Kingsmen (Thames) Inc. / Havelock Corners (Kingsmen)

Lot/Unit: 29 Phase/Building: 4B Model/Floor Plan: Lancaster(5001)Elev B 4 BED-3+1
BATH

SCHEDULE "B-1"
Floor Plan

Sketch #1

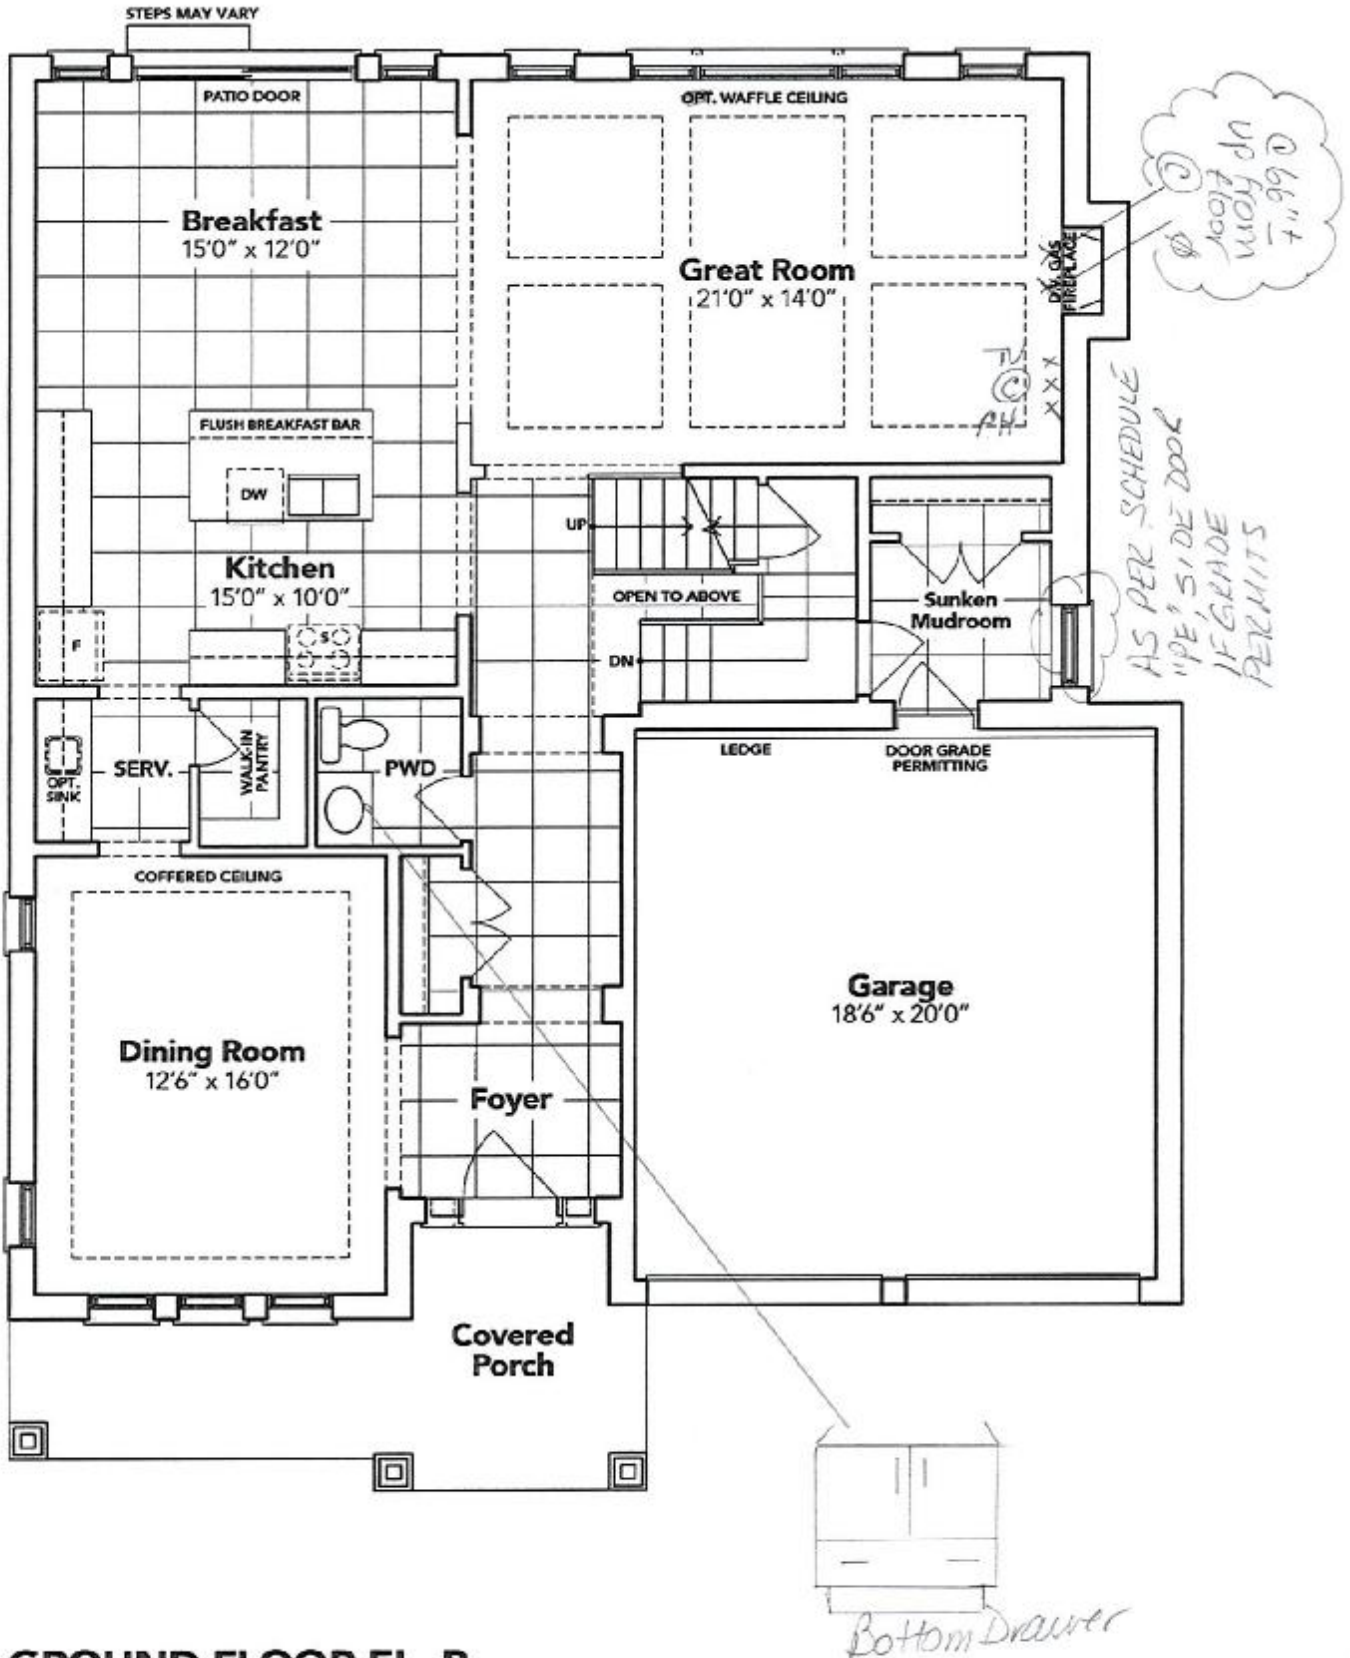
Inv.5082	1 - To supply & install the standard T.V. rough in in the great room and master bedroom... see sketch # 1 & # 2	
Line 66553	Note:	
12Aug21 / 23Aug21		
Inv.5082	1 - To supply & install the standard Phone (CAT 5) rough in in the great room, master bedroom and bedroom # 2.. See sketch #1 & # 2	
Line 66555	Note:	
12Aug21 / 23Aug21		
Inv.5082	1 - To SUPPLY AND INSTALL AN ADDITIONAL BASIC RECEPTACLE (NOT DEDICATED) at approx. 66" + - up from the floor centerd + - to the F/P mantle on the great room	
Line 66556	Note: See sketch # 2	
12Aug21 / 23Aug21 THIS IS FOR A FUTURE WALL MOUNT T.V.		
Inv.5082	1 - To SUPPLY AND INSTALL CONDUIT FOR TV OVER THE FIREPLACE – TERMINATED IN SAME ROOM at approx. 66 " + -up from the floor centered + -to the F/P mantle and terminated next to + - the std. T.V. and Phone(CAT 5) rough in in the great room..see sketch # 1	
Line 66557	Note: THIS IS FOR A FUTURE WALL MOUNT T.V.

Inv.5082	1 - To supply & install the Option WAFFLE CEILING in the great room... see sketch # 1	
Line 66547	Note:	
12Aug21 / 23Aug21

Sketch #4.
p Just sub

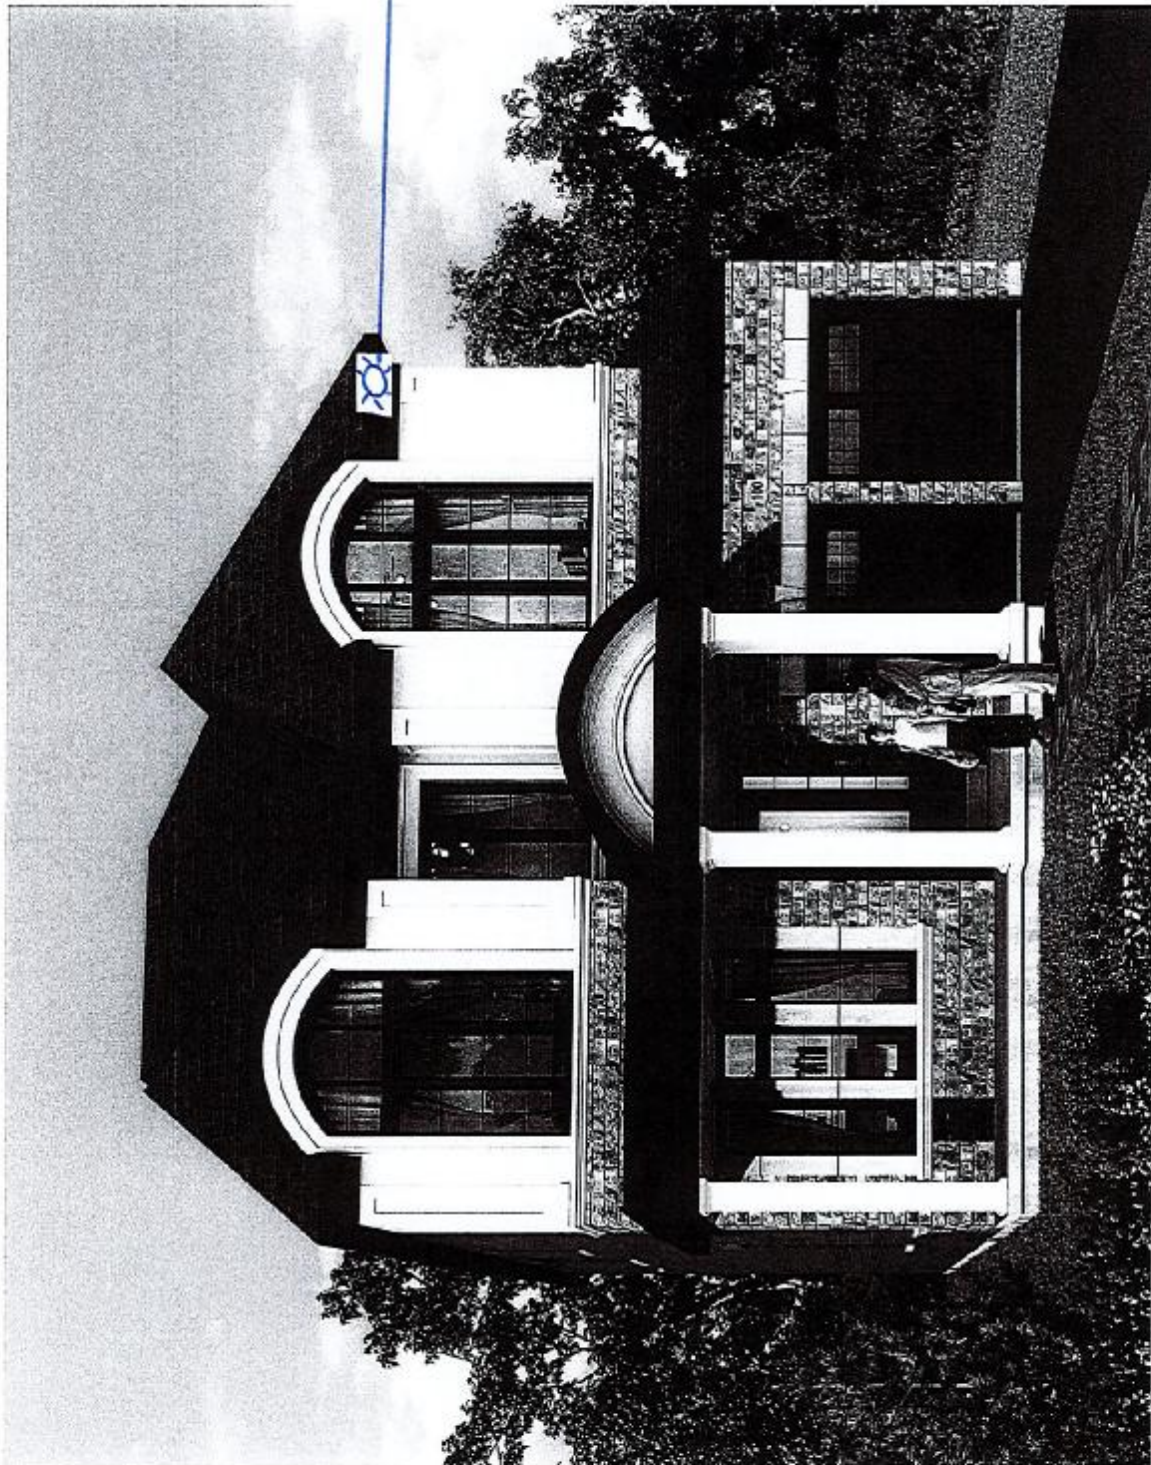
12Aug21 / 23Aug21		
Inv.5082	1 - To supply and install ONE LED exterior potlight on a separate switch.. see sketch #4	
Line 66558	Note:	
12Aug21 / 23Aug21		
Inv.5082	1 - Relocate the standard ceiling light from the main staircase landing to the O.T.B. area on the second floor.. see sketch # 2	
Line 66559	Note:	
12Aug21 / 23Aug21		
Inv.5082	1 - To SUPPLY AND INSTALL REINFORCING FOR A CEILING light at the O.T.B. area on the second floor at staircase.. see sketch # 2	
Line 66560	Note:	
12Aug21 / 23Aug21

ONE EXTERIOR POTLIGHT

LOT 29 THAMES PH. 4 B
RE: UPGRADED FREE STANDING TUB FOR
MASTER ENSUITE

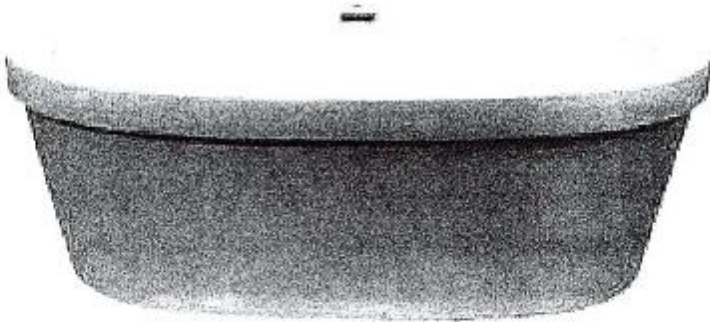
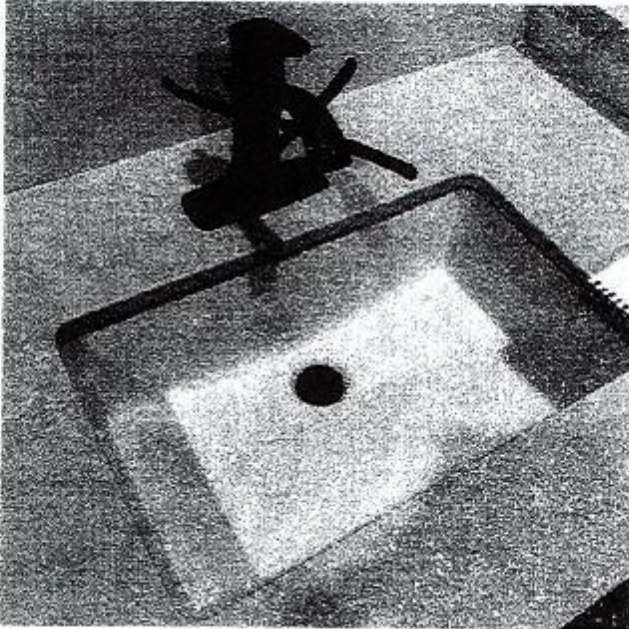
Inv.5082	2 - To change the bath tub to a stand up shower (including frameless glass panel with door and pot light) for the shared bathroom and Ensuite # 2 ... see sketch # 2	
Line 66548	Note:	
12Aug21 / 23Aug21		
Inv.5082	3 - To increase the height of the toe tester in all bathroom showers (master, Bedroom #2, and shared bathroom) to approx. 28"+- from the unfinished floor	
Line 66549	Note:	
12Aug21 / 23Aug21		
Inv.5082	1 - To supply and install the Mirolin BROOKE free standing tub in the master ensuite, in lieu of the standard free standing tub... see spec's	
Line 66550	Note:	
12Aug21 / 23Aug21
